Access Compliance Report

Public Rights-of-Way

Intersection ID: 9255	Main Street: BOOKER_AV	Cross Street: CAMPUS_ST	Location: SW
ADA ID: BFB6BACC6136	Ramp Type: BlendTrans1	Initial Pass/Fail: Fail	Overall Compliance: No
			Severity Score: 18.75

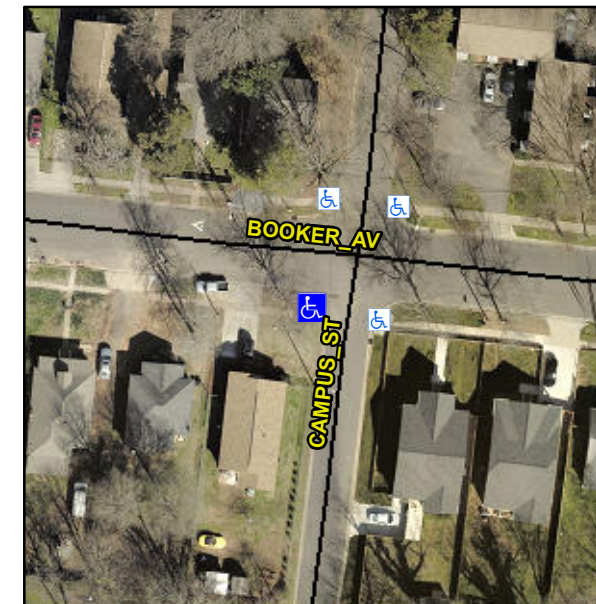
Not Found, R304.5.1, R304.5.3

Compliance	Description	Data	Compliance	Description	Data
N/A	Ramp Length (in)	59.5	Yes	BlendTrans Slope (%)	2.7
No	Ramp Width (in)	32.0	No	BlendTrans XSlope (%)	3.2
N/A	Flare Type LT	N/A	N/A	Flare Type RT	N/A
N/A	Flare Slope LT (%)	N/A	N/A	Flare Slope RT (%)	N/A
N/A	Flare Traversable LT?	N/A	N/A	Flare Traversable RT?	N/A
N/A	Landing Length (in)	N/A	N/A	DWS Provided?	N/A
N/A	Landing Width (in)	N/A	N/A	DWS Contrast?	N/A
N/A	Landing Slope (%)	N/A	N/A	DWS Length (in)	N/A
N/A	Landing X Slope (%)	N/A	N/A	DWS Full Width?	N/A
N/A	Landing Curb? (Y/N)	N/A	N/A	DWS Offset (in)	N/A
N/A	Shared Landing?	N/A			
N/A	Gutter Ponding?	N/A	N/A	Gutter Slope (%)	N/A
N/A	Gutter Lip Ht (in)	N/A	N/A	Gutter X Slope (%)	N/A
N/A	Painted X Walk1?	No	N/A	Painted X Walk2?	No
	X Walk 1 Direction	To E		X Walk 2 Direction	To N
	X Walk 1 Width (in)	N/A		X Walk 2 Width (in)	N/A
	X Walk 1 Slope (%)	1.9		X Walk 2 Slope (%)	3.2
	X Walk 1 X Slope (%)	3.3		X Walk 2 X Slope (%)	0.9

Remove & Replace Curb Ramp With Two New Directional Ramps or Equivalent.
